## Fishermans Bend Planning Review Panel

RE: Fisherman's Bend Framework – Draft for consultation – Delivering Montague

To help articulate our concerns, the image<sup>1</sup> on page 2 shows the current established bike paths for the Port Melbourne area:

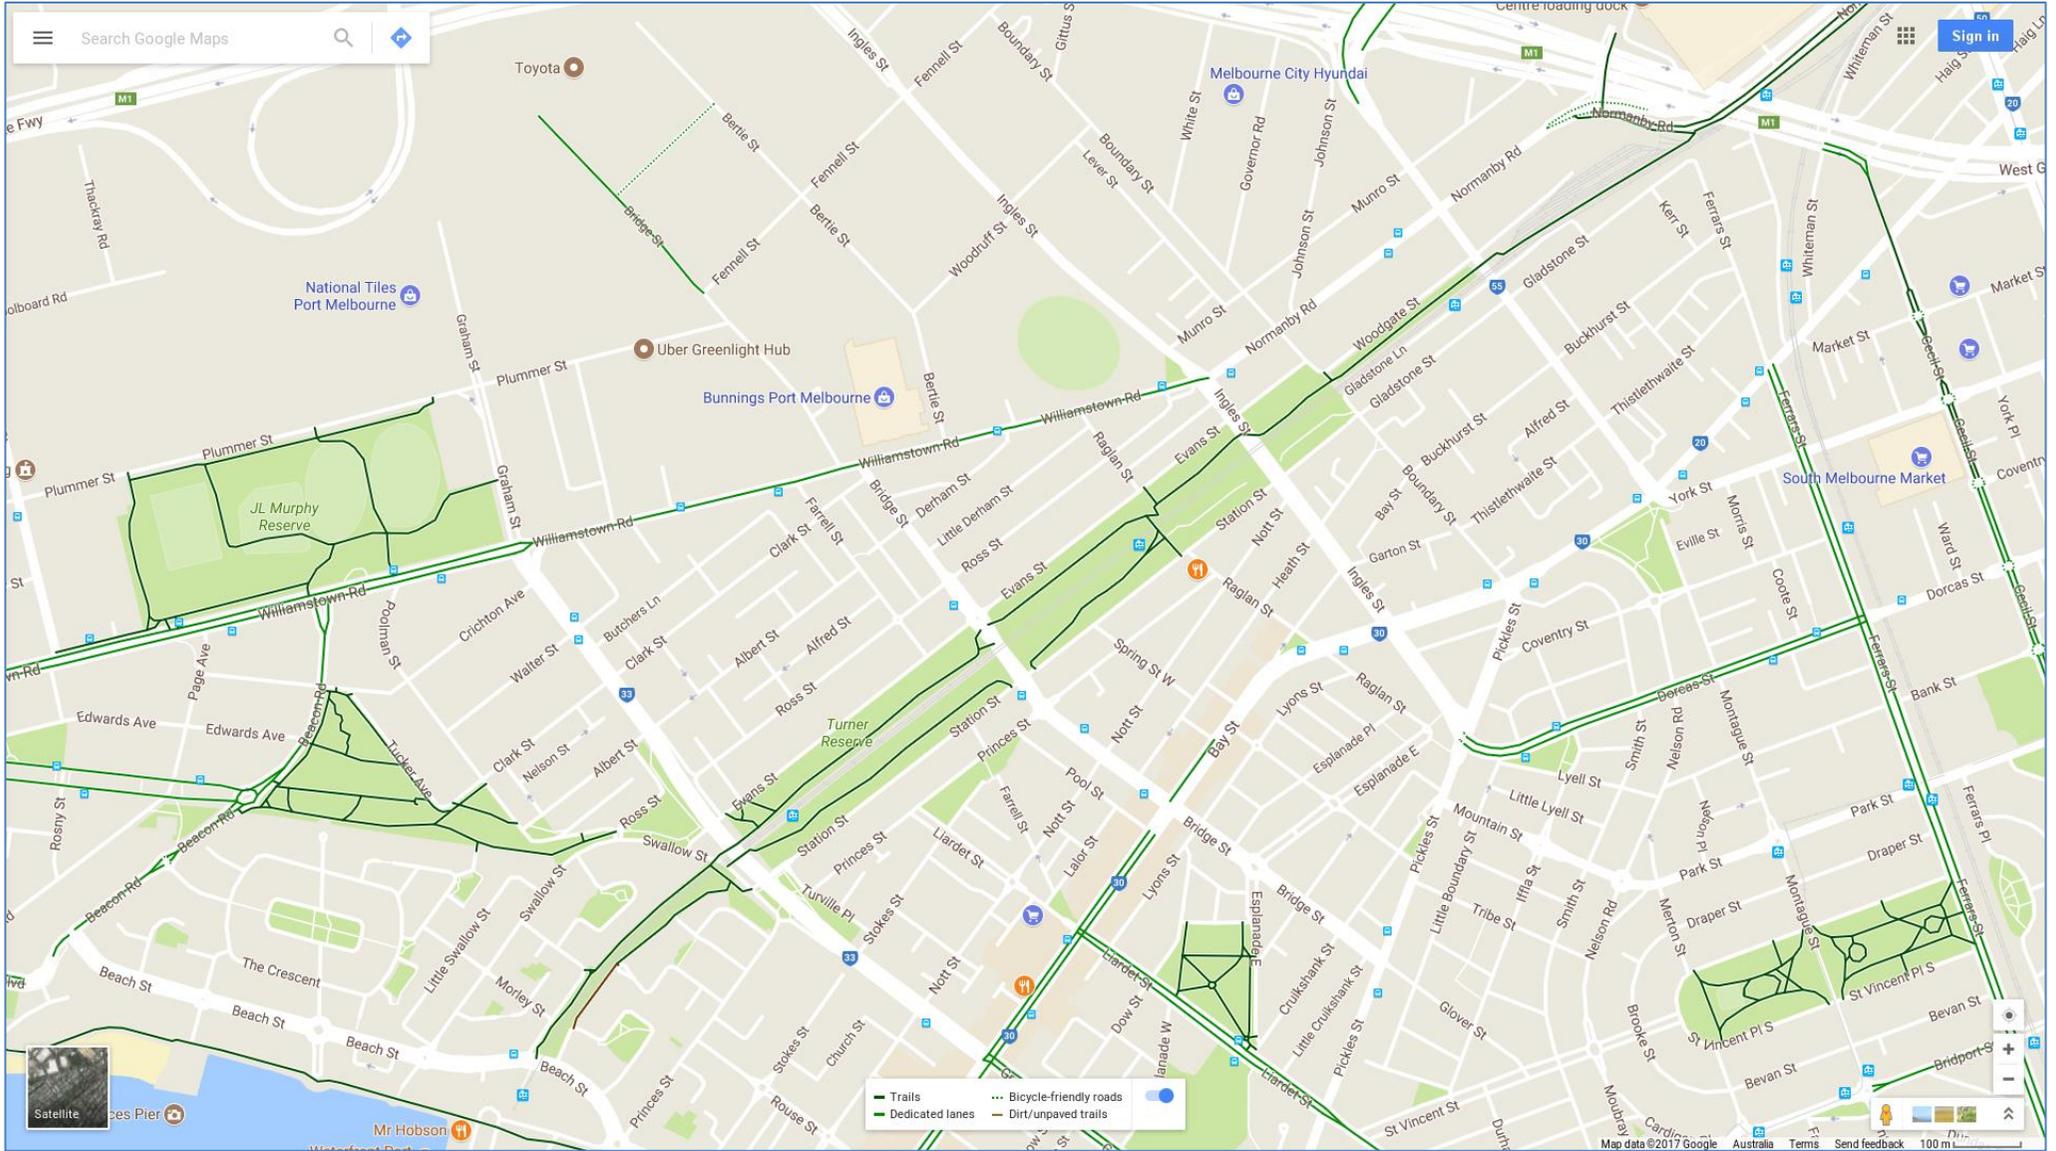
DELWP's draft document identifies changing the bike path from the South Bank Depot Tram Stop to Bay Street via Buckhurst St. This proposal would require crossing 3 major arterial roads (Montague Street, Ingles Street, and Bay Street @ Crockford Street).

As shown in the above map, there is already a cycle trail that follows the tram line from South Bank Depot to Beacon Cove via Turner Reserve which already:

- Utilises the existing Montague Street bridge to go over traffic.
- Utilises the existing crossing at the Tram crossing on Ingles Street.
- Has no requirement to blend into Bay Street at Crockford Street.

With the DELWP draft plan, the impacts would be:

- Dangers to cyclists crossing Montague Street, or;
- Additional traffic management on Montague Street to allow cyclists safe crossing, impacting already strained traffic conditions.
- Dangers to cyclists crossing Ingles Street at Bay Street, or;
- Additional traffic management on Ingles Street to allow cyclists safe crossing, impacting already strained traffic conditions.
- Dangers to cyclists trying to enter Bay Street at Crockford Street.
- Unnecessary hazards to residents of Bay Street, many of which are elderly, by cyclists.

As the plan indicates the removal of the Southbank Tram Depot and its conversion to an open space, any current safety issues for cyclists crossing on the existing trail would disappear at that stage and follow the natural establish path down Turner Reserve, with minimal widening required between Normanby Road and Ingles Street.

A short cycle path could be established from the Southbank Depot Tram stop to the Ferrars Street Primary School and Community Facility for students/staff without significant impact to surrounding areas.

By retaining the cycle trail down through Turner Reserve, this would allow a "fan-out" of trails to surrounding areas, including the new proposed precincts Sandridge and Wirraway, instead of numerous trails that would cause safety hazards and/or impact traffic along arterial routes.
